# **80C196NU, 83C196NU SPECIFICATION UPDATE**

Release Date: July, 1997  
Order Number: 272864-003

The 80C196NU, 83C196NU may contain design defects or errors known as errata. Characterized errata that may cause the 80C196NU, 83C196NU's behavior to deviate from published specifications are documented in this specification update.

### **005.        *RPD Signal***

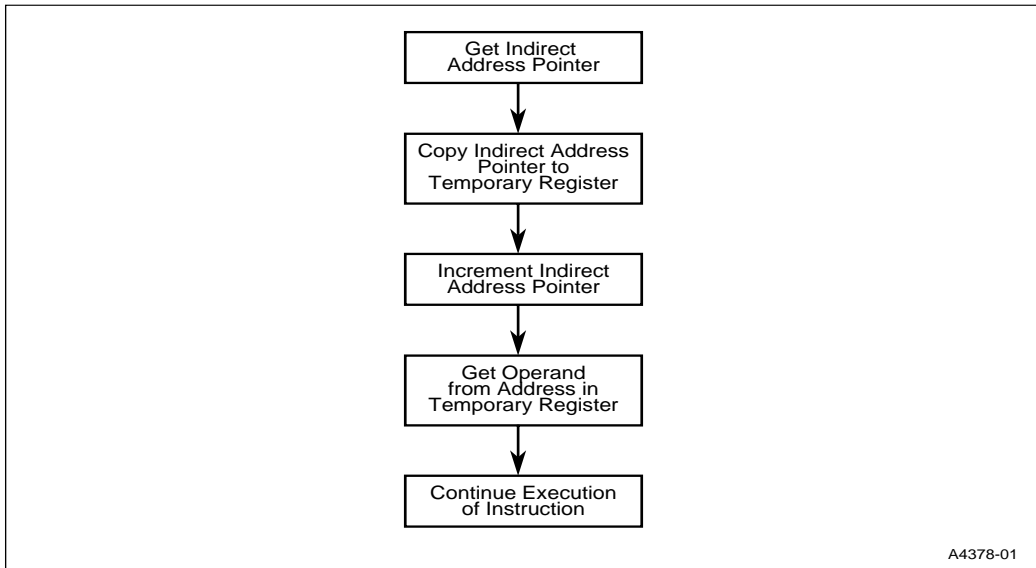
**PROBLEM:** If your application uses an external interrupt input to return to normal operation from powerdown mode, and the phase-locked loop (PLL) circuitry is enabled (see PLEN2:1 signal description), connect a capacitor between RPD and V<sub>SS</sub>. The

capacitor is used to establish a delay of at least 2 ms to allow the PLL circuitry to stabilize before the internal CPU and peripheral clocks are enabled.

If your application uses powerdown mode, but the phase-locked loop (PLL) circuitry is disabled, the capacitor is not required.

If your application does not use the powerdown mode, leave the RPD pin unconnected.
